PETITION FOR VARIANCE APPLICATION

Badger Project
AEI Project # 18463-00
November 12, 2018

Petition for Variance – Electrical
ASHRAE 90.1 9.4.1.1[a]

Attachment 1: Variance Summary

1 ELECTRICAL LIGHTING PLAN - LEVEL 1
SCALE: 1/8" = 1'-0"

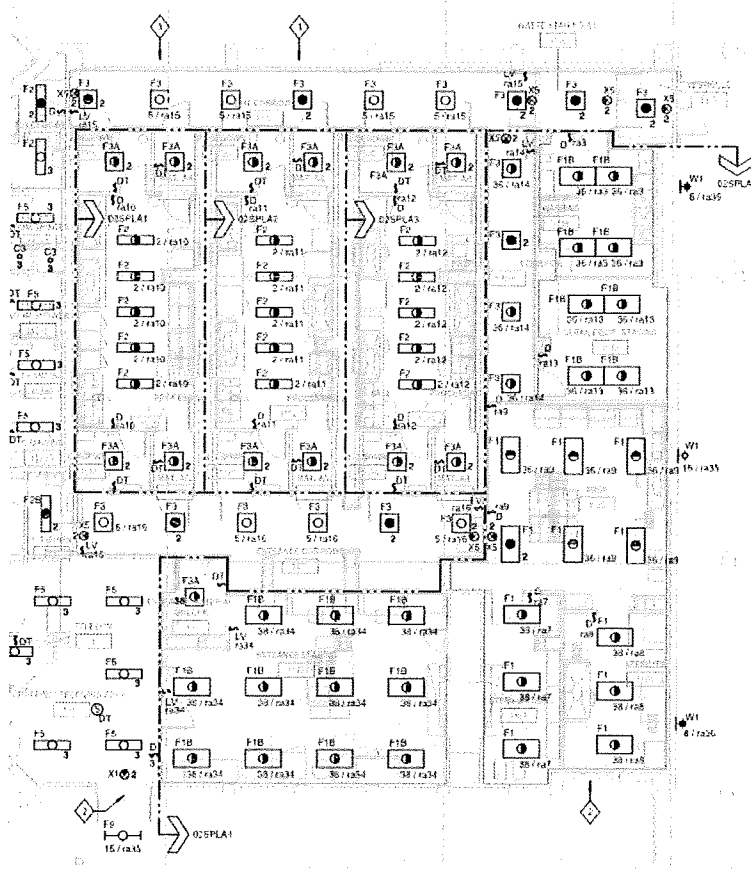
Lighting control in the cGMP production labs and adjacent corridors will be accomplished through a central time-schedule relay control system. See the sheet E-101 graphic for identified CDMO laboratory spaces and adjacent corridors. Lights will turn on and remain on throughout regular business. Outside of business hours, non-emergency lights in the areas will shut off. Occupants of cGMP laboratory and corridor spaces will have the ability to manually override the scheduled shutoff through a personal tablet interface with the building automation system (BAS). Laboratory workers will have this personal tablet with them as they navigate and occupy these spaces. The proposed lighting control design removes the vulnerable devices and faceplates from the spaces while providing energy use reduction through scheduled shutoff outside of business hours, and it allows local control and override of scheduled shutoff as necessary.
